Historic District Commission

TUESDAY – January 11, 2022 - 6:00 P.M.

Subject – New Construction – 148 Ottawa Dr. – HDC 21-21

The applicant/contractor VIP Restoration, LLC has made petition to the Historic District Commission to construct a 2,222 sq.ft., 2-story home on the subject property. The Planning Division has conducted a review of the criteria for Historic District Appropriateness, and the Secretary Standards for Rehabilitation from Department of Interior. The proposed new construction should also be consistent with the standards approved in the City of Pontiac Ordinance for Historic Preservation.

SHEET TITLE
ELEVATIONS

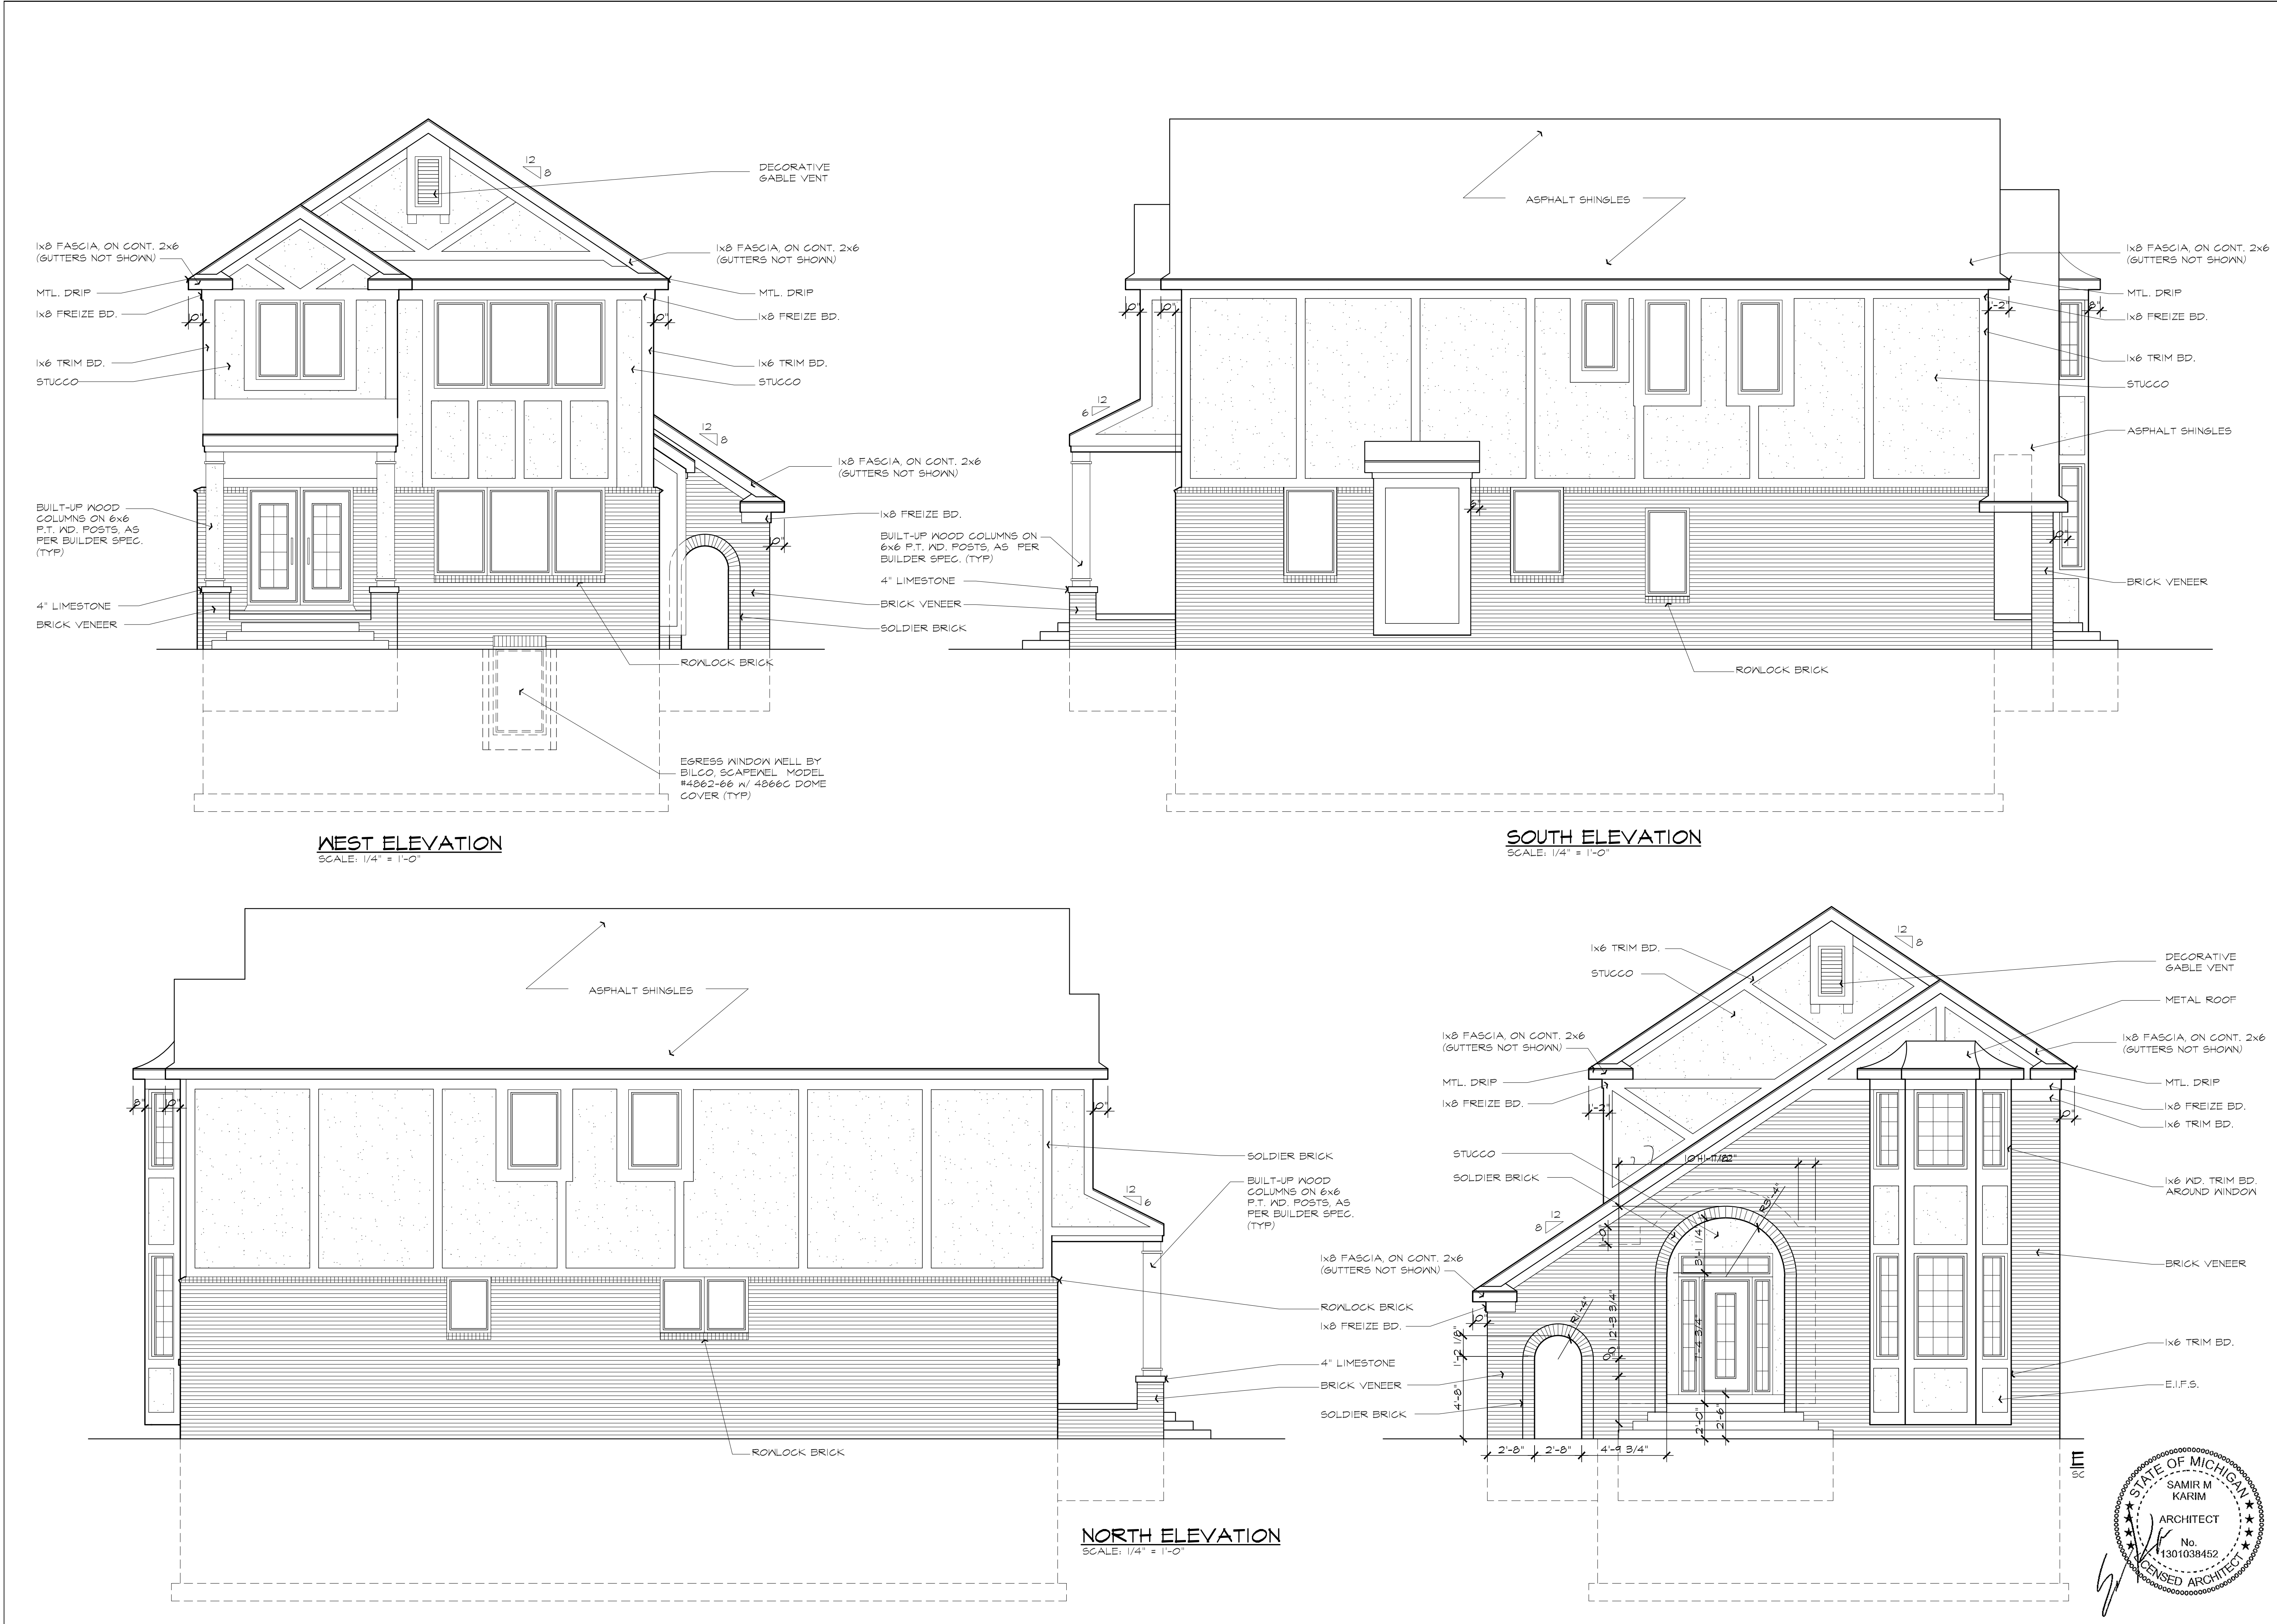
- Height – The Proposed structure is similar height of the former structure of 2-stories. **[MEETS]**
- Width – The Proposed structure is similar in width **[MEETS]**
- Proportion of Principal Facades – The structure does not maintain a proportionate front facade similar to the former building. **[DOES NOT MEET]**
- Roof Shape – The proposed structure does match the historic roof pitch and gable. **[MEETS]**

- Composition of Principal Façade – The front façade of the proposed structure does reflect the identified historical contributing characters. **[MEETS]**
- Rhythm and Proportion of Openings – Pattern and opening design elements are not reflected in the proposed home design. **[DOES NOT MEET]**
- Rhythm of Entrance Porches and other Projections – Proposed Porch and Windows to do not reflect the characteristics of the former building. **[MEETS]**
- Relationship of Materials, Texture, and Color – The architectural style, and use of materials do not reflect the contributing characters of the former structure. **[MEETS]**

The Planning Division recommends to the Historic District Commission to **Approve** HDC 21-21, for the new construction of a single family home, proposed at 148 Ottawa Dr. The Planning Division recommends to the applicant to resubmit housing construction plans that reflect the comments and review criteria mentioned in the Planner's Report.
